# Sonia Sweaters Ltd. (9932)

604, Kondolbagh Taibpur, Ashulia Road, Savar

28.April.2014

No waterproofing at roof level

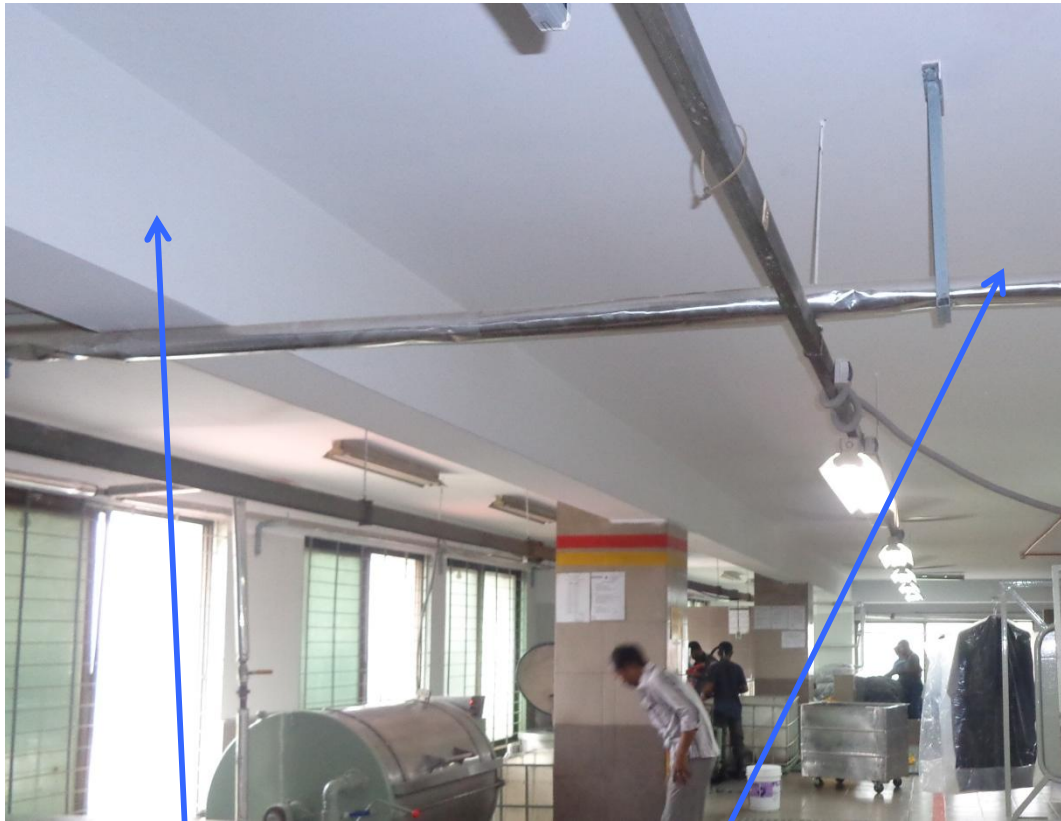
No waterproofing membrane was visible on the roof of the building. This means that any cracks in the surface finishes on the roof will allow water to seep into the concrete slab beneath the finishes, and cause long-term soaking of the slab. The same applies to all water tanks at roof level.

- Apply a new waterproofing membrane at roof level.
